APPLICATION NO.	FILING DATE	FIRST NAMED INVENTOR	ATTORNEY DOCKET NO.	CONFIRMATION NO.	
10/623,768	07/21/2003	Koji Sakai	4041K-000140	4041K-000140 4834	
27572	7590 10/29/2004		EXAM	EXAMINER	
HARNESS,	DICKEY & PIERCE	JIMENEZ, MAI	JIMENEZ, MARC QUEMUEL		
P.O. BOX 82 BLOOMFIE	28 LD HILLS, MI 48303	ART UNIT	PAPER NUMBER		
	•		3726		
		DATE MAILED: 10/29/2004

Application No.	Applicant(s)				
Office Action Summary		10/623,768	SAKAI ET AL.	\mathcal{N}			
		Examiner	Art Unit				
		Marc Jimenez	3726				
The MAILING DATE of this communication appears on the cover sheet with the correspondence address Period for Reply							
THE - Exte after - If the - If NC - Failu Any	ORTENED STATUTORY PERIOD FOR REPLY MAILING DATE OF THIS COMMUNICATION. Insions of time may be available under the provisions of 37 CFR 1.15 SIX (6) MONTHS from the mailing date of this communication. It period for reply specified above is less than thirty (30) days, a reply period for reply is specified above, the maximum statutory period were to reply within the set or extended period for reply will, by statute, reply received by the Office later than three months after the mailing ed patent term adjustment. See 37 CFR 1.704(

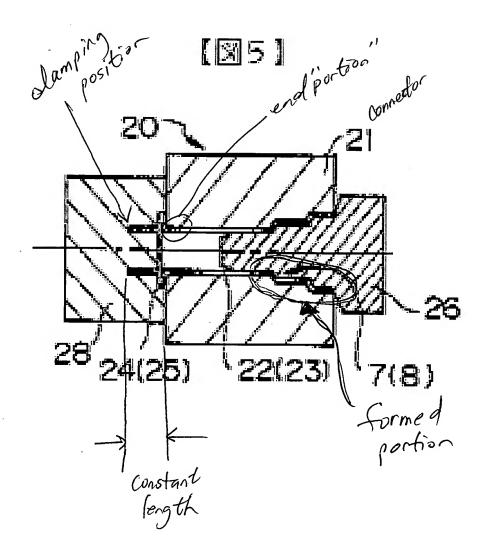
Seiji teaches a method of manufacturing piping 22 having a joining portion, the piping 22 having a connector 21 at an end portion, comprising the steps of: clamping and fixing 28 a portion of the pipe 22 for adjusting a length of the pipe 22 simultaneously when the connector 22 is attached to the end portion; engaging the connector 21 having a through-hole with the end portion of the pipe; and forming 7 the end portion of the pipe 22 to the connector 21 so that the length from the clamping position 28 to the end portion of the pipe 22 can be constant, wherein the length of the pipe 22 is reduced when an excess material of the pipe 22 is absorbed by the formed portion (at 7) so as to adjust the length of the pipe 22 to a predetermined value. As shown in figure 4, the pipe extends beyond the right face of the connector 21. As the punch 27 is moved to the left in figure 4, the material of the pipe will be moved to the left and flush with the face of the right face of the connector 21 as shown in figure 7. As the material is deformed to the left and into the faces 7 of the connector, the material will be absorbed by the formed portion at 7.

8. Applicant argues that that Seiji does not teach the concept of adjusting the pipe length. However, as shown in figure 4, the pipe extends beyond the right face of the connector 21. As the punch 27 is moved to the left in figure 4, the material of the pipe will be moved to the left and flush with the face of the right face of the connector 21 as shown in figure 7. As the material is deformed to the left and into the faces 7 of the connector, the material will be absorbed by the formed portion at 7. The teachings in Seiji is therefore considered to meet the claim limitations "..... clamping and fixing a portion of the pipe for adjusting a length of the pipe simultaneously when the connector is attached to the end portion, ..." as recited in claim 14. See mark up of Seiji fig. 5 below.
